**MUNICIPAL CORPORATION,
KARACHI.**

Reference No. B. S. P. 471/40

Re: Proposed Building on Plot
No.74, S.B.4, Siddar Bazar Qr.

PLAN SHOWING PROPOSED BUILDING

SECTION ON AB

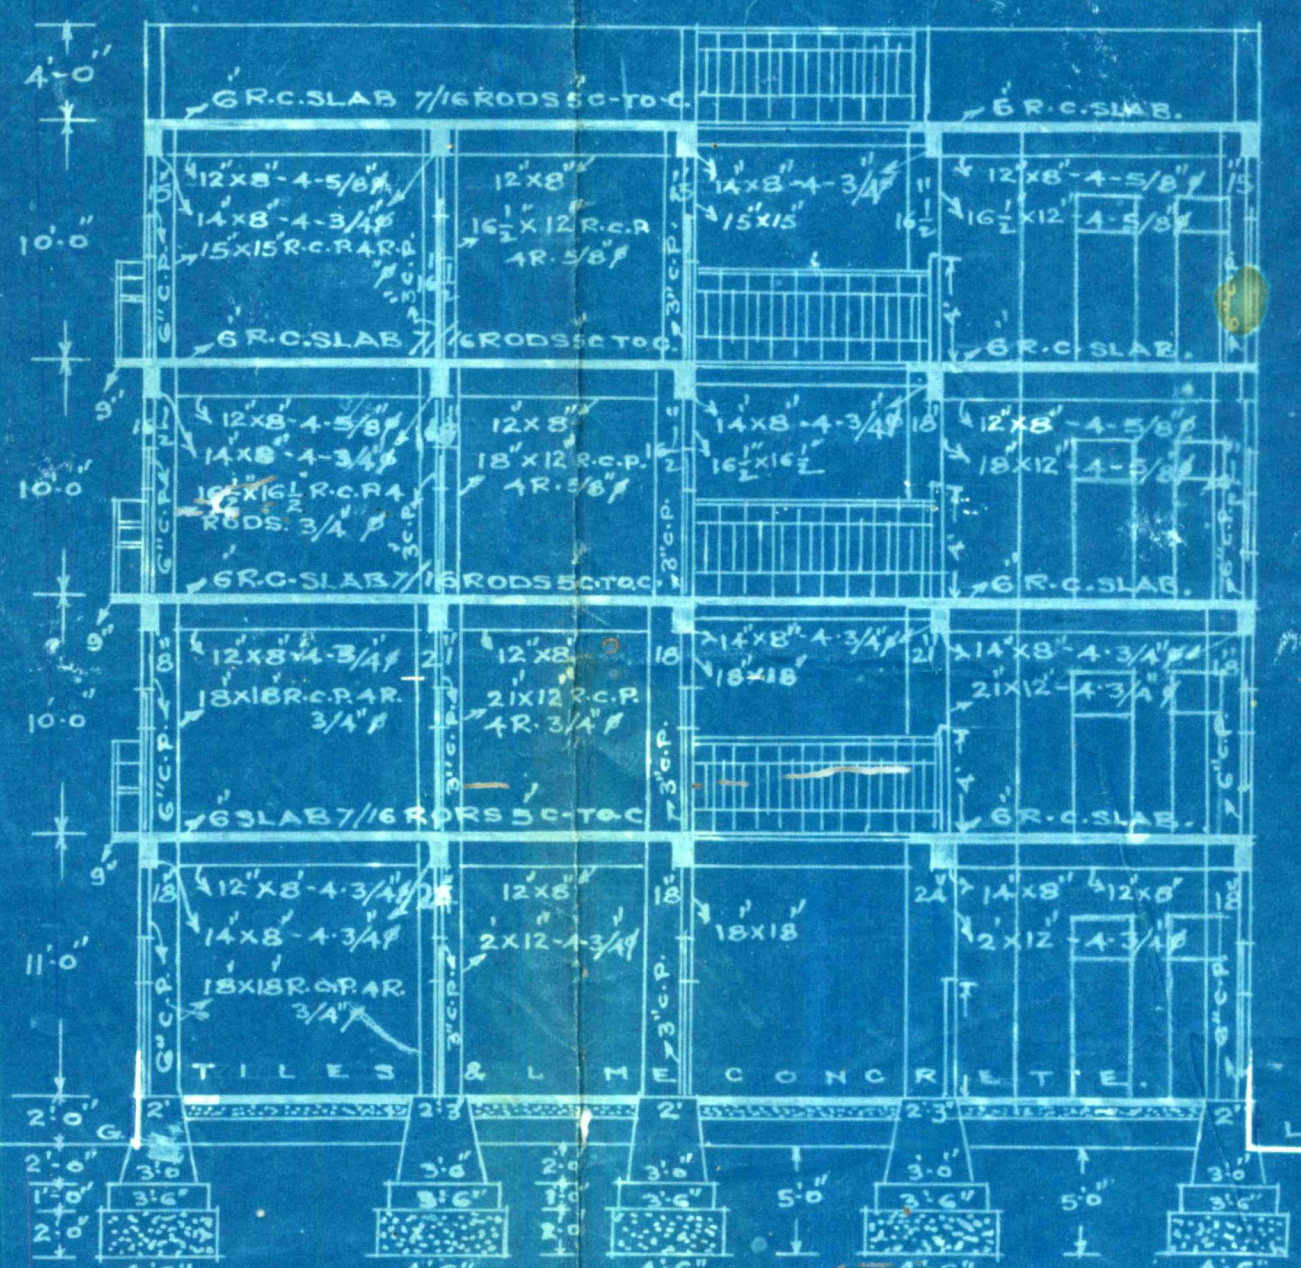
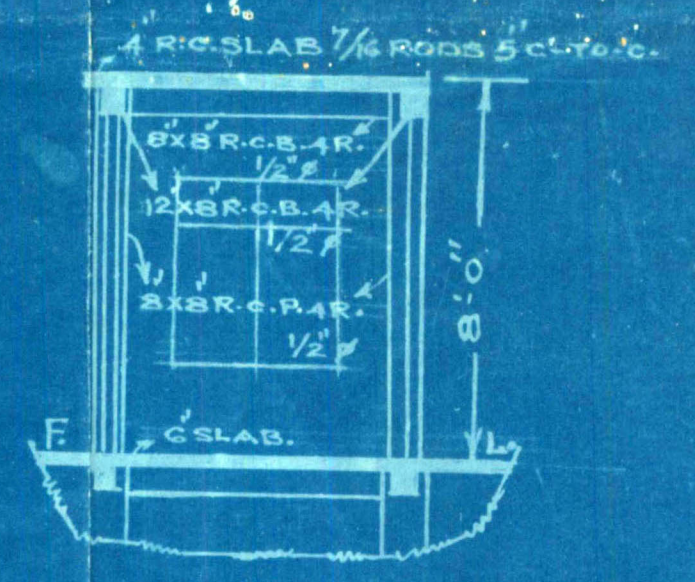
- (2) Verandahs and kitchens will be dark.
(3) Obj. 6 dated 20-10-40 stands
(4) Plinth offset on Municipal land should be removed from section

- (1) Obj. 6 dated 20-10-40 stands
- (2) Plinth offset on Municipal land should be removed from elevation
- (3) Orders are requested if the verandahs can be said to be properly lighted & ventilated as stated by the architect.
- (4) It was suggested by us that the window on the passage should be changed into jalliwork in order to admit more light. The architect declines to do it. Orders are requested if the window be deemed sufficient.
- (5) Orders are requested on L.S.'s objection also

(4) As already stated in my letter dated 25th October 1940, the plinth offset shall be within the Owner's limit. However, as desired, the same has been removed from the section.

GROUND FLOOR

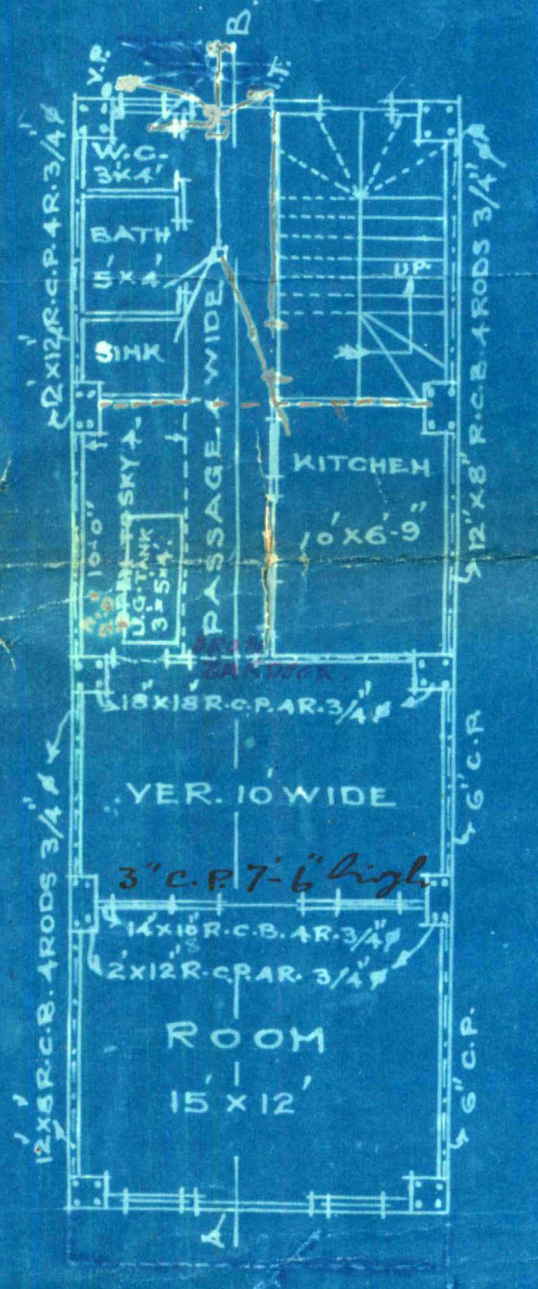
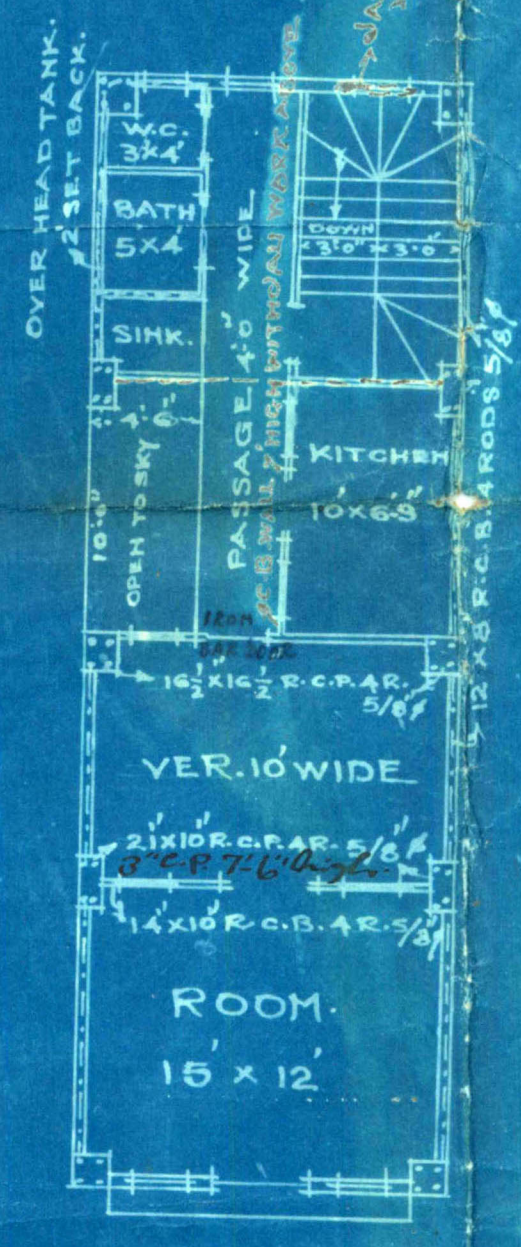
- (1) One window in the small open space 10'-0"x4'-6" will not light up the verandahs, which will still be dark.
- (2) Objection re. the Title deed stands.

- (1) One window in the small open space 10'-0" x 4'-6" will not light up the verandah, which will still be dark.
- (2) Objection re. the Title deed stands

1. As already stated in my previous letters dated 25th October 1940 and 2nd December 1940, the Verandahs shall have ample light as portions of the same abut on the open to sky. Besides, as suggested, the partition walls between the rooms and the Verandahs shall also be raised to the height of 7'-6" only, whereby the Verandahs will get plenty of light through the rooms also.

(2) As already stated in my letter dated 25th October 1940, the verandahs shall have ample light as portions of the same abut on the open to sky. The kitchens also shall have plenty of light from the open to sky which they are directly facing with windows towards the said open to sky.
